AQUALLIANCE

April 29, 2022

Re: Butte Subbasin Groundwater Sustainability Plan

Butte Final GSP Table 2-7 Modified - Water Budget Summary: Land and Surface Water System.

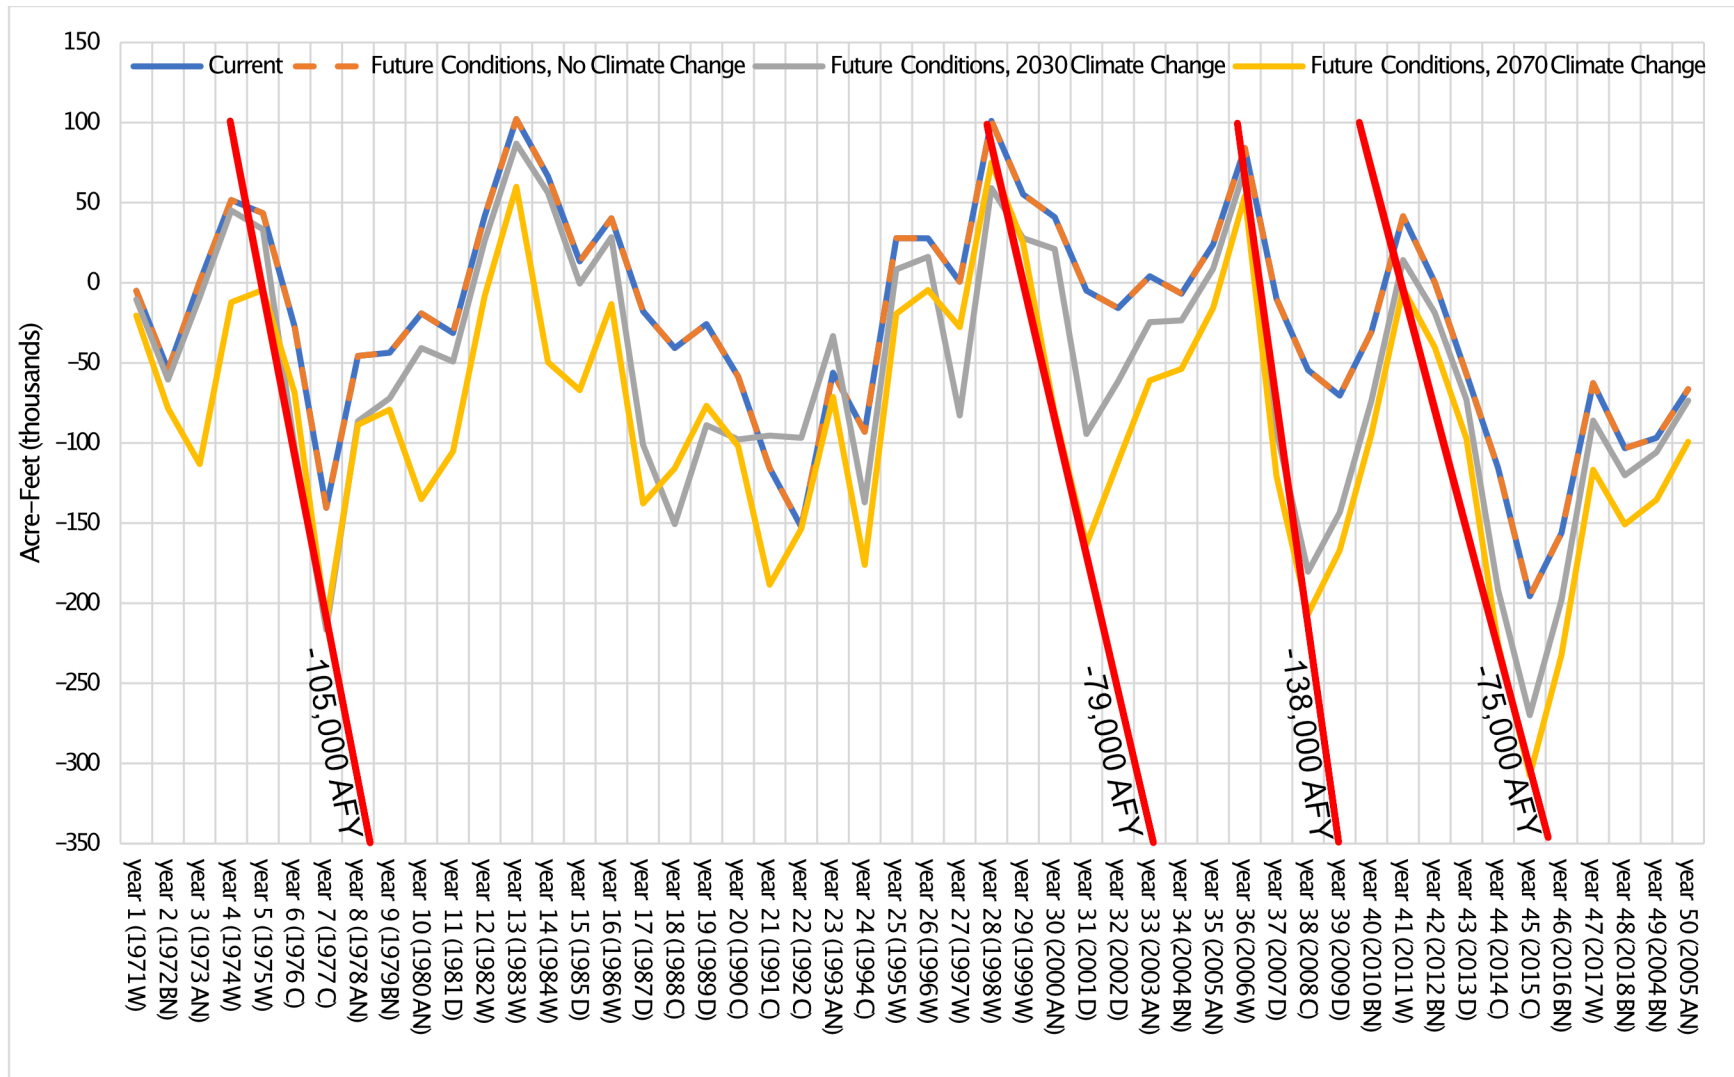
4. AquAlliance Exhibits 2 and 3 are modifications of Groundwater System Water Budget Table 2-8 and Land and Surface Water System Water Budget Table 2-7 with added columns that calculate the difference between the Historical 2000-2018 water budget and the Future 2070 Climate Change water budget. Row 28 in this exhibit lists the change in groundwater storage for the different scenarios. For the Historical period, the annual change in groundwater storage is -9,800 afy (column B). With the 2070 Climate Change scenario the annual change in groundwater storage is a -2,000 afy (column F). This is an improvement in the annual average loss in storage of 7,800 afy (column G, row 28), but the proposed management of the subbasin will still result in a loss in storage of 100,000 af over the next 50 years. The loss in storage is in addition to the approximate 186,000 af lost between 2000 and 2018 (Figure 2-25, p. 2-49, pdf 132; 19 yrs x -9,800 afy = -186,200 af). The total loss in groundwater storage since 2000 with the 2070 Climate Change scenario is predicted to be approximately 286,000 af (186,200 afy + 100,000 afy = 286,200 afy) with the maximum future loss during consecutive below normal water years estimated at up to 486,000 af (Figure 2-44, p. 2-90, pdf 173; 300,000 afy + 186,200 afy = 486,200 afy).

14. The water balance in the Butte GSP assumes that with the 2070 Climate Change scenario the management of the subbasin will result in an increase in groundwater production of 68,300 afy, (AquAlliance Exhibit 2, rows 21, column G). This increase in pumping will occur with a decrease in groundwater discharging to surface water, and a change in net stream accretion, of -189,000 afy (AquAlliance Exhibit 2, row 29, column G), or 466% below the 2000-2018 baseline of 40,600 afy (row 29, columns H and B). The loss in net stream accretion occurs because of an increase in seepage from streams with climate change of 86,000 afy (row 10, column G) and a reduction in groundwater discharging to the streams of -95,000 afy (row 25, column G). This is a ratio of future stream seepage to increased groundwater pumping of 126% ($86,000 \text{ afy} / 68,300 \text{ afy} = 1.26 = 126\%$). This is also a ratio of future net loss in stream accretion to increased groundwater pumping of approximately 277% (AquAlliance Exhibit 2, row 30, column G). This decline in future streamflow that significantly exceeds the increase in groundwater production raises several questions the issue of whether the proposed Butte GSP will sustainably manage the subbasin:

- The historical net stream accretion, 40,600 afy (row 298, column B), occurred with groundwater pumping of 142,200 afy (row 21, column B), a ratio of net accretion to pumping of approximately 29% (row 30, column B). With the 2070 Climate Change scenario, the management plan estimates that the net stream accretion will be -148,500 afy (row 29, column F), for an approximate 466% decrease in groundwater discharging to surface waters over the 2000-2018 Historical baseline (row 29, column H). Why is this reduction in net stream accretion considered a beneficially sustainable management practice? Shouldn't a decrease in stream flows that's significantly greater than the increase in groundwater production be considered an ecological tipping point that causes an undesirable result to interconnected surface waters and an impact to the Public Trust?

Modified Figure 2-44. Cumulative Change in Groundwater Storage for Current and Future Conditions Baseline Scenarios.

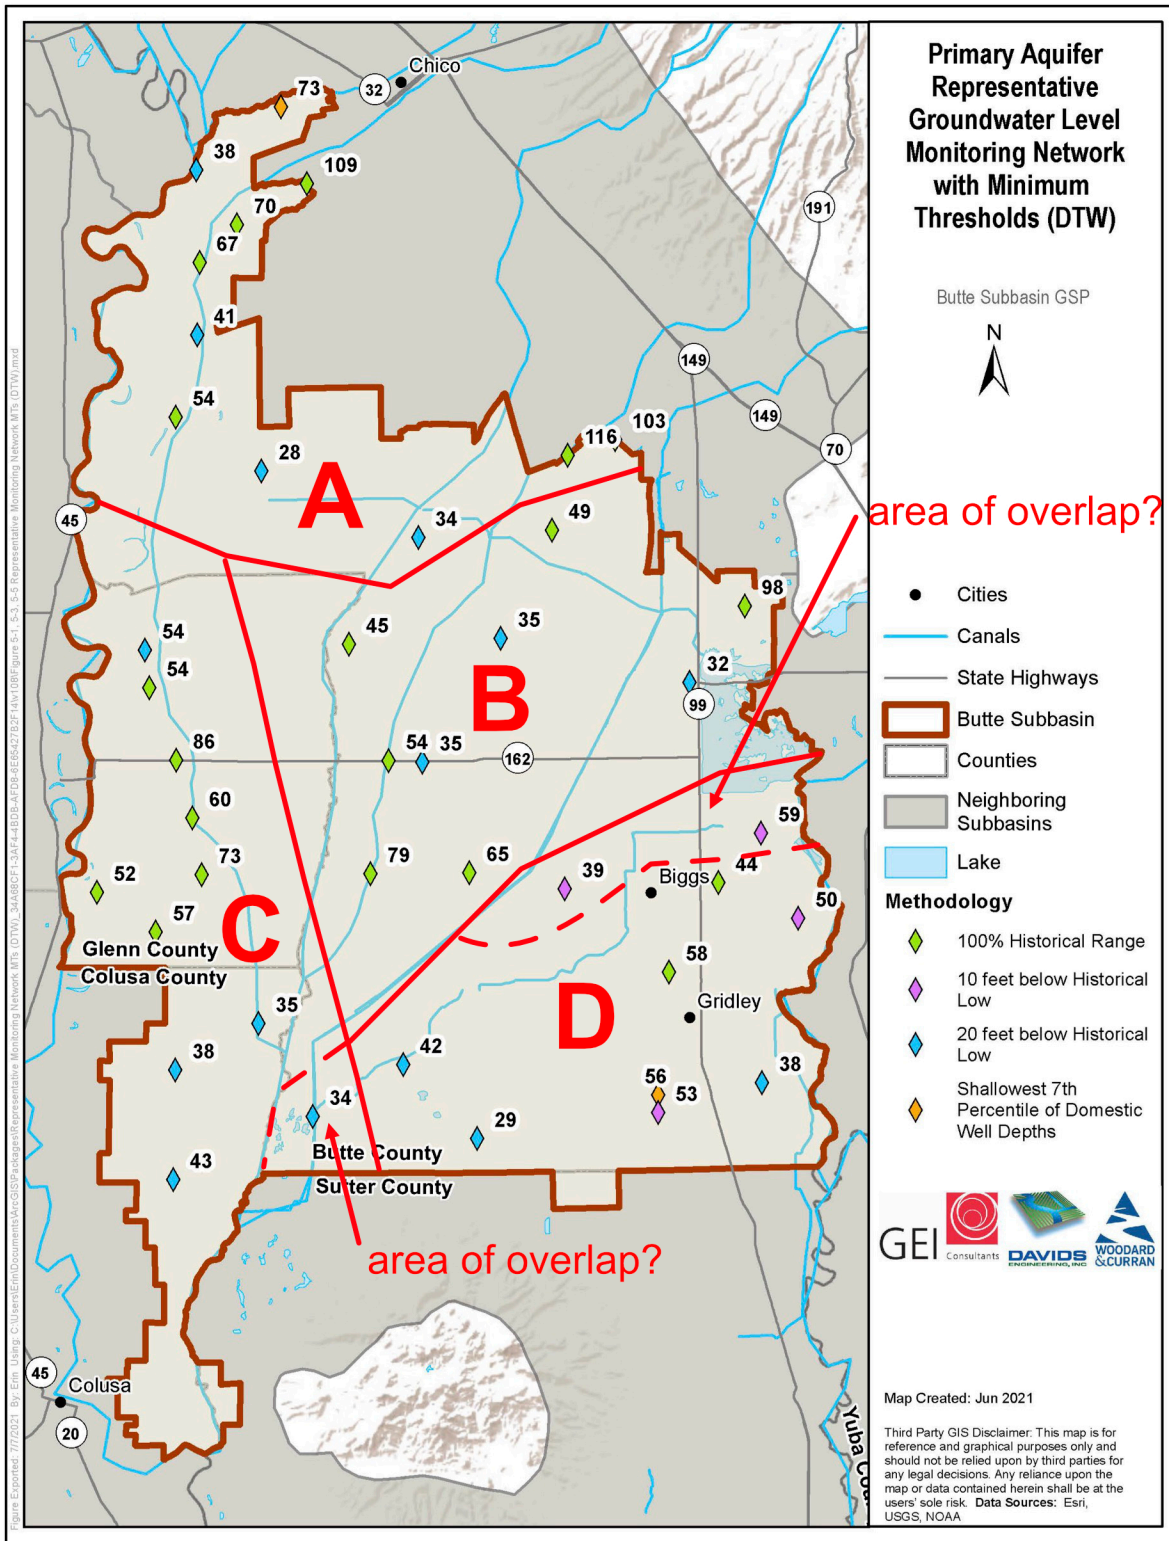
6. AquAlliance Exhibit 4 is a modification of Figure 2-44 that shows the cumulative changes in Butte Subbasin groundwater storage with the Current and future Climate Change scenarios. Lines have been added that mark the range of slopes of groundwater storage decline during years of consecutive below normal water years, i.e., a drought. These drought changes in storage are estimated for the 2070 Climate Change scenario to range from approximately -75,000 afy to -138,000 afy with an average of -99,250 afy. These drought year declines in groundwater storage are significantly greater than the 2070 Climate Change 50-year average of -2,000 afy by approximately 3,750% to 6,900% ($75,000 \text{ afy} / 2,000 \text{ afy} = 37.5 = 3,750\%$). The total loss during these droughts ranges from approximately 250,000 af to 300,000 af. This loss in storage during periods of drought is caused by significant decline in groundwater levels, which likely causes additional losses in the flows in interconnected streams and harm to groundwater dependent ecosystem (GDEs). The large difference between the long-term average annual rate in storage loss and the loss during extended periods of below normal water years suggests that sustainable management of the Butte Subbasin would be better measured by the impacts caused during droughts and how actions of the GSA prevent undesirable results during periods of extended below normal water years to protect all groundwater beneficial uses and users.

AquAlliance Exhibit 4 is a modification of Figure 2-44 that shows the estimated cumulative change in storage for different modeled scenarios, with lines added that show the drought rates of storage loss for the 2070 Climate Change scenario. The rate of change in groundwater storage during the simulated 2070 droughts is from -75,000 afy to -138,000 afy with an average of -99,250 afy.

As an example of a drought-based methodology, AquAlliance Exhibit 4 shows the annual loss in groundwater storage that, during the most recent simulated periods of drought lasting more than 3 years, has an average annual loss of approximately -99,250 afy. Using this average rate of annual drought storage loss for 3 years, the average volume of groundwater produced from a foot decline in the shallow aquifer level of 21,000 af/f (see Comment No. 2), a 3-year decline in groundwater level would be of approximately 14 feet ($3 \text{ yrs} \times -99,250 \text{ afy} / 21,000 \text{ af/f} = -14.2 \text{ feet}$). This suggests that the depth of the MTs should be set at 15 feet or less below the MO depth to accommodate future periods of extended drought without causing undesirable impacts to all

Modified Figure 4-1: Primary Aquifer Representative Groundwater Level Monitoring Network with MTs (DTW) with boundaries of hypothetical groups of 25% drawn.

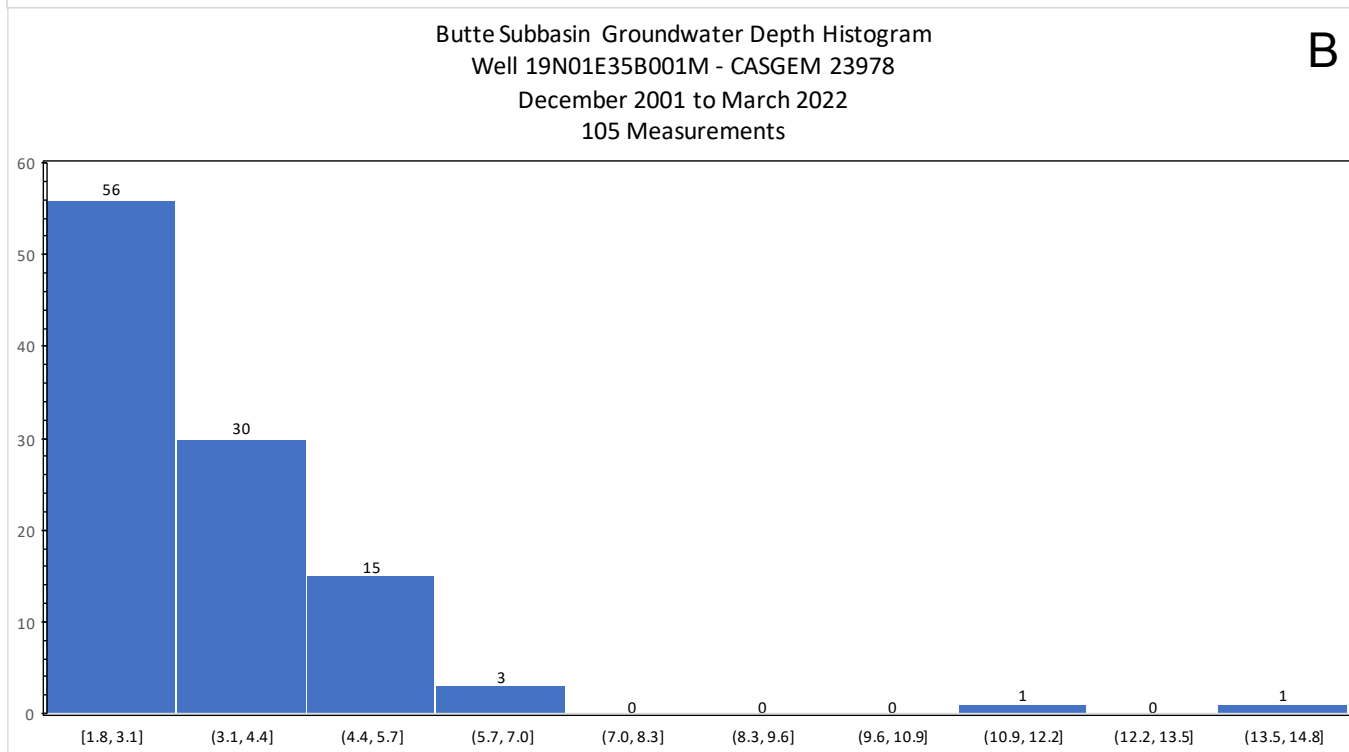
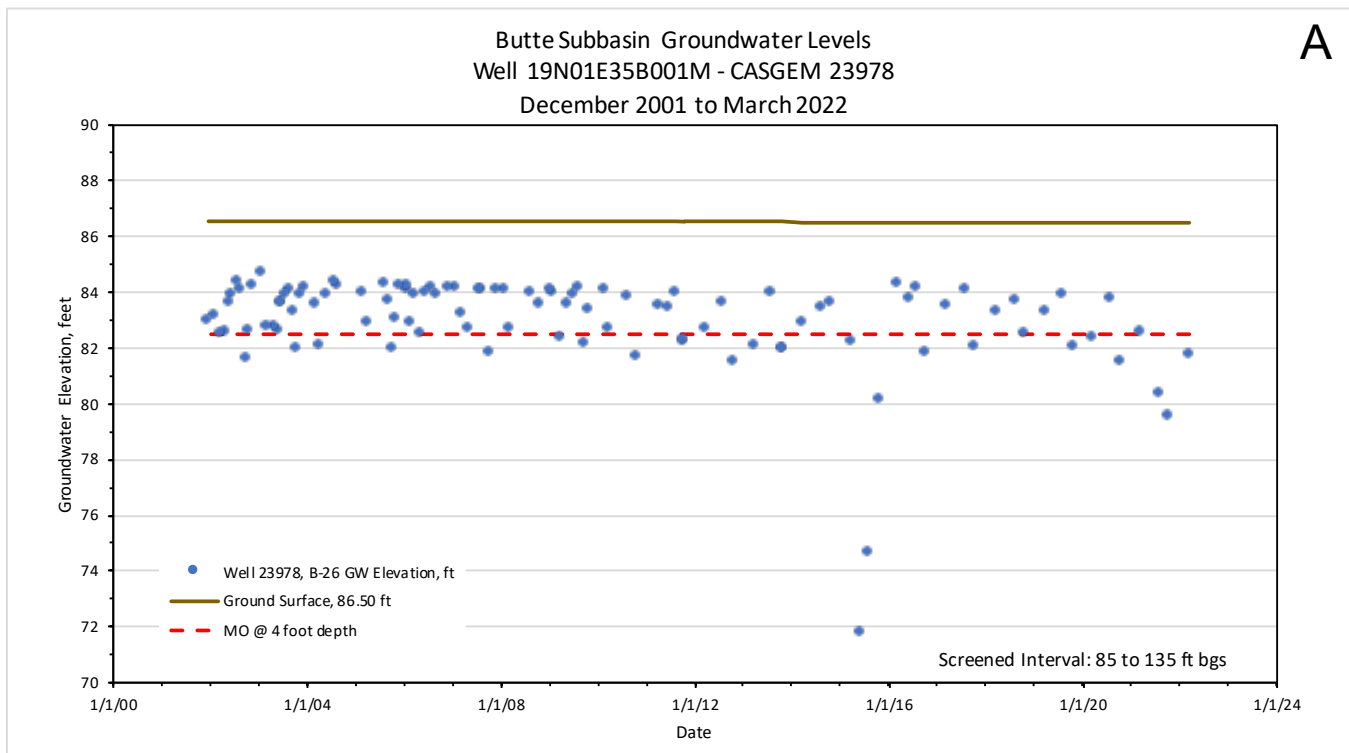
12. AquAlliance Exhibit 5 is Butte GSP Figure 4-1 showing the Primary Aquifer RMS well MT values (p. 4-17, pdf 215) with hypothetical boundaries for four 25% well groups added, labeled A to D. This exhibit demonstrates groups of wells that are adjacent rather than dispersed. Assuming all RMS groundwater wells belong to a 25% group, the wells stay in the same group, and the grouping doesn’t change with the measurements, then there needs to be an overlap of the 25% group boundaries to create four groups of 11 wells out of a total of 41 wells. These hypothetical groups also demonstrate that the MT depths within a group are highly variable.

For example, in the center of the subbasin, 25% group labeled B, two adjacent RMS wells along Highway 162 have MT depths of 35 and 54 feet. The 35-foot MT is for well 19N01E35B001M (B-26, CASGEM 23978) with screens from 85 to 135 feet bgs; for State well numbers (see Figure 3-1, p. 3-7, pdf 183) and well B-26 in AquAlliance Exhibit 1 for well details. Also note that this shallow well, B-26, is also part of the Interconnected Surface Water monitoring well network and has a second MT depth of 25 feet bgs for that sustainability indicator. The 54-foot MT is for an intermediate depth well 19N01E27Q001M (B-25, CASGEM 19782) screened from 260 to 280 feet bgs. AquAlliance Exhibits 6 and 7 are hydrographs and histograms of groundwater elevation data from CASGEM for these two wells with the ground surface and MO elevations included. The hydrographs show that groundwater elevations seasonally fluctuate from 2 to 5 feet. The histograms show that 99% of groundwater depths measured in shallow well, B-26, since December 2001 have been less than 10 feet (AquAlliance Exhibit 6B). For the intermediate depth well, B-25, 86% of the groundwater depths have been less than 10 feet since April 1978, and 96%

Butte Subbasin Groundwater Levels
Well 19N01E27Q001M - CASGEM 19782
April 1978 to October 2021

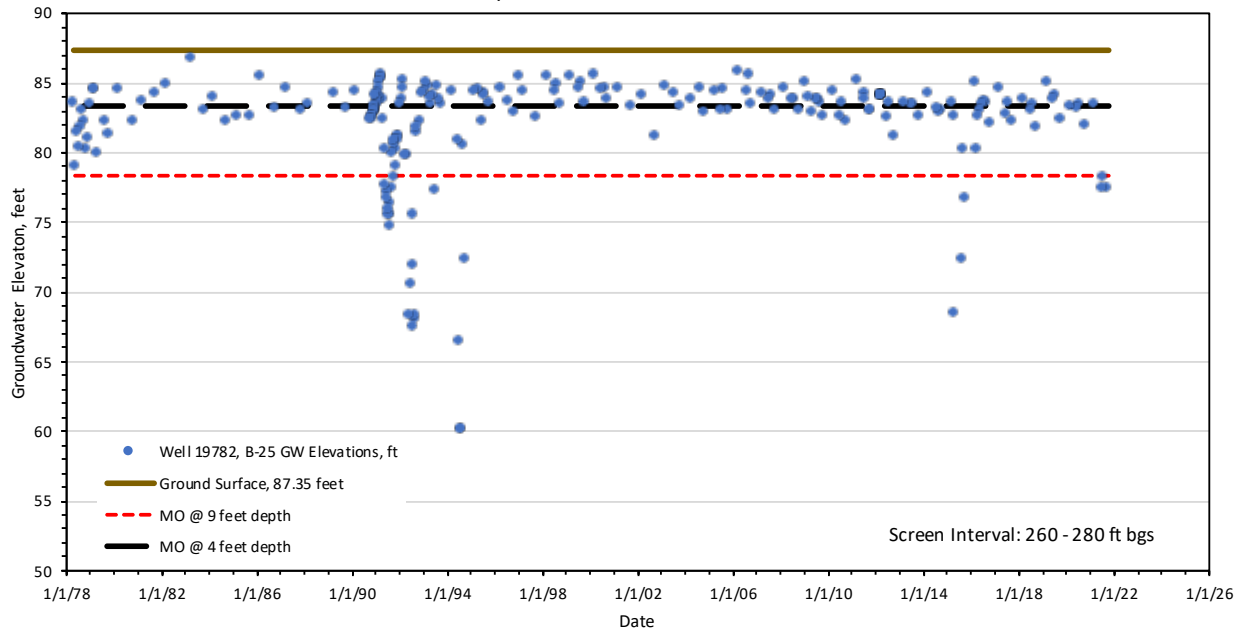
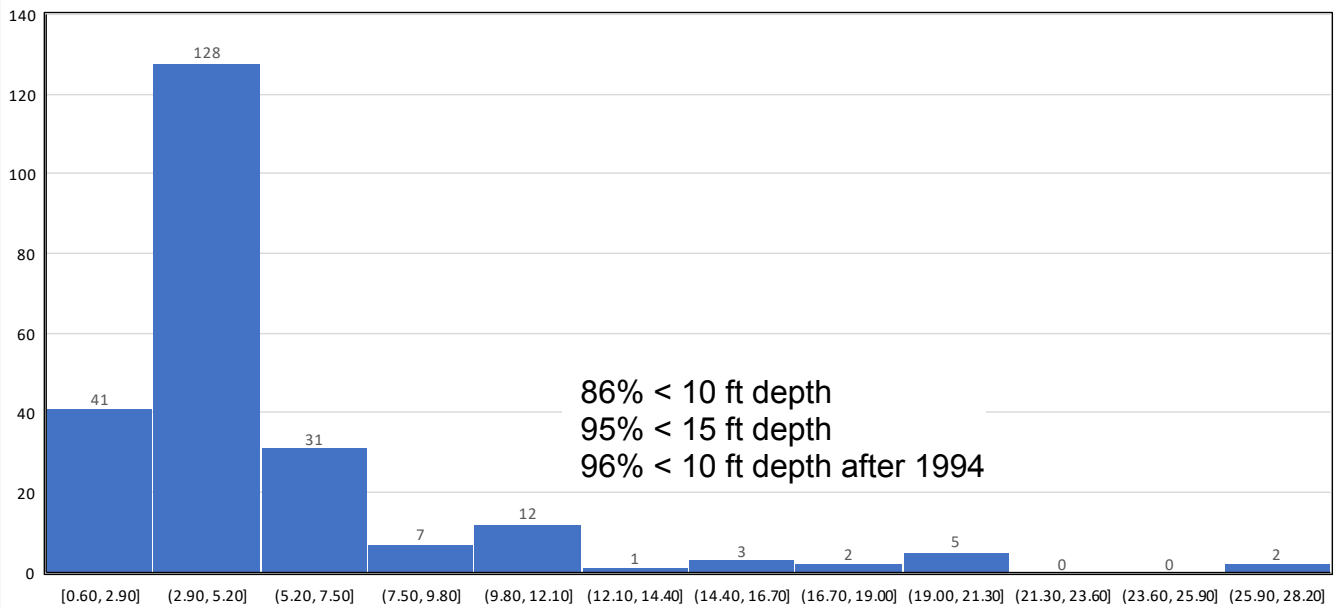
after 1994 (AquAlliance Exhibit 7B). The depth in the shallow well B-26 exceeded 10 feet twice during the 2012-2015 low in June at 14.71 feet, and August 2015 at 11.83 feet. In the intermediate well, B-25, depth exceeded 10 feet three times during 2012-2015 — May, August, and October 2015 — with the maximum depth at 19 feet bgs in May.

These two wells are less than 1 mile apart, and the middle depth of the screened intervals is approximately 160 vertical feet apart. Historical groundwater level data from CASGEM shows that the depth to groundwater in both wells is typically less than 5 to 10 feet, with the average in recent years less than 5 feet. Historical CASGEM data show that the difference in groundwater elevations between these wells has ranged from -1 to -2 feet, except for the years 2015 and 2021, when the difference ranged from -2 to -3.4 feet (AquAlliance Exhibit 8A). Using the vertical screen difference of 160 feet, the historical vertical groundwater gradient between these two wells ranges from approximately -0.013 to 0.021 (AquAlliance Exhibit 8B). Assuming that these two wells in the center of the subbasin and less than a mile apart are in the same 25% RMS groundwater level monitoring group, the requirement that the MTs in these wells be exceeded together for 24 consecutive months before an undesirable result can occur raises several questions:
